# UNITED STATES PATENT AND TRADEMARK OFFICE

10/509,434

<b>Office Action Summary</b>	<b>Application No.</b> 10/509,434	<b>Applicant(s)</b> DAY, TONY	
	<b>Examiner</b> HELENA KOSANOVIC	<b>Art Unit</b> 3749

## DETAILED ACTION

(fig. 4 of Ledbetter)

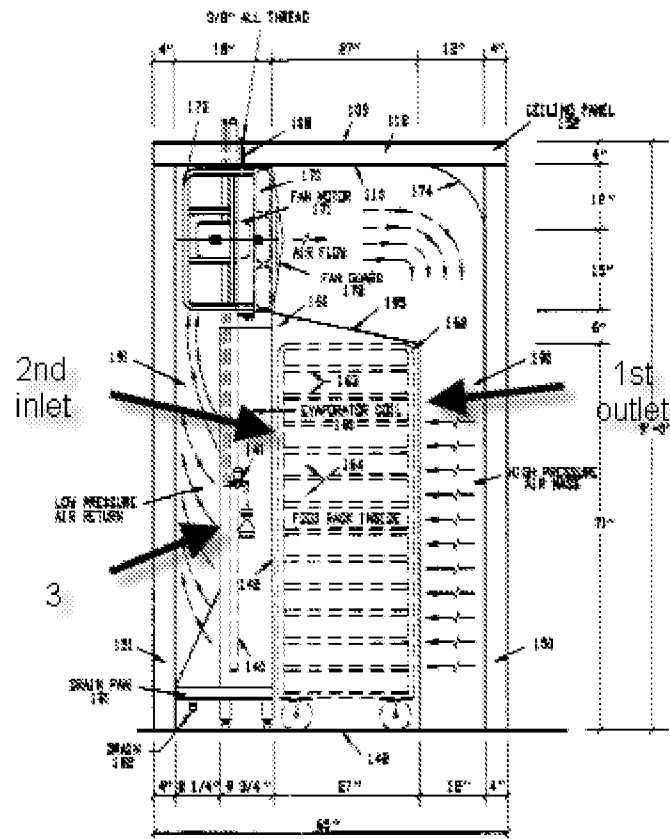
Regarding claims 52 and 56 they are also rejected based on the consideration of the first inlet, first air plenum and first air outlet as shown in paragraph 6 of this Office Action. First inlet 1 described as first outlet in discussion above, with first air plenum 1' and first outlet 1" wherein the first inlet extends substantially a full vertical extent of at least one of the array and the first plenum.

6. Examiner marked originally unmarked elements with darkened arrows for clarification.

(Alternatively fig. 4 of Ledbetter)

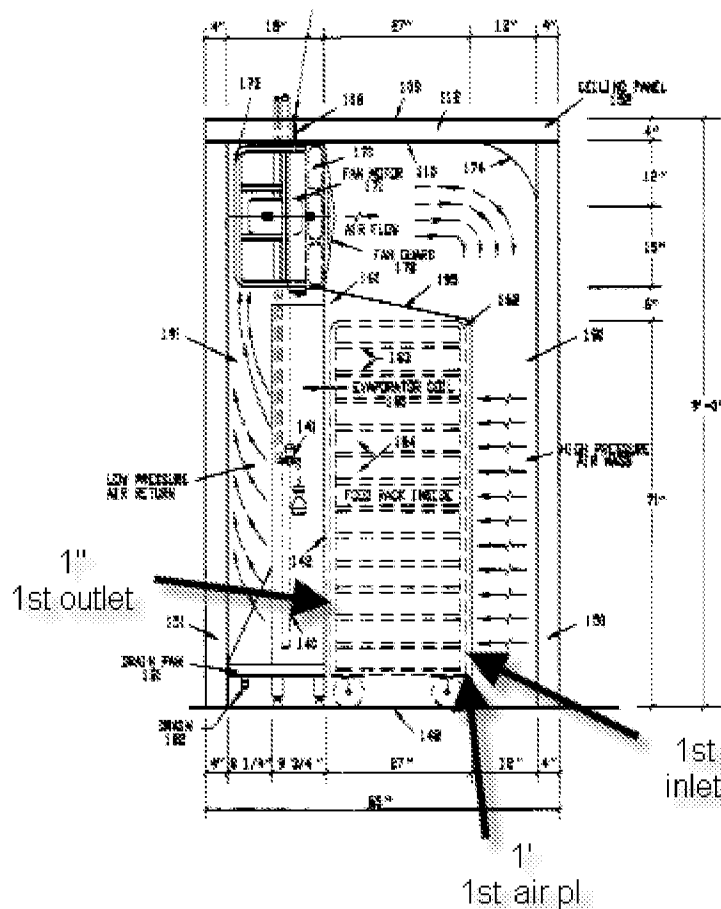
Ledbetter teaches an invention as discussed above and further: a mechanism 173,180 for cooling and recirculation of the air between mechanism chamber 191 (fig. 4) and equipment chamber 163,164, wherein the shell and divider wall are configured to direct the air to the mechanism that may have at least one fan (fig. 16) positioned downstream from the fan wherein the flow of the air through equipment chamber 163,164 is substantially parallel to and opposed to the flow of the air through mechanism chamber 191 (fig. 4);
